RESPONSE DOCUMENT

RIVERLEA MAJOR DEVELOPMENT

Precinct 3A Subdivision

APPLICATION TO AMEND THE EIS

Figure 5 - Channel 6 - Typical cross sections

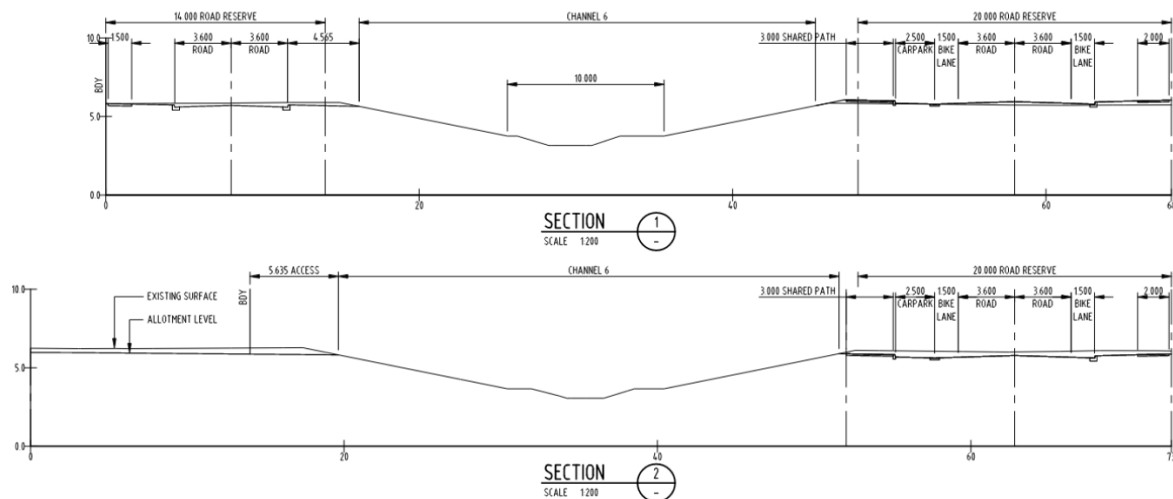
The Council requested that Walker demonstrate space proofing for a shared-use path (northern side), maintenance path, channel's slope batter, indented parking bays, street tree planting, etc.

Walker Response: A typical cross-section of Channel 6 (shown in Figure 5 and Appendix A) is between road corridors on either side, with adjacent lots on one side and the road on the opposite side.

The typical cross-sections demonstrate space proofing for the shared-use path, maintenance path, channel slope batter, indented parking bays, and street tree planting along the southern side of Macquarie Drive.
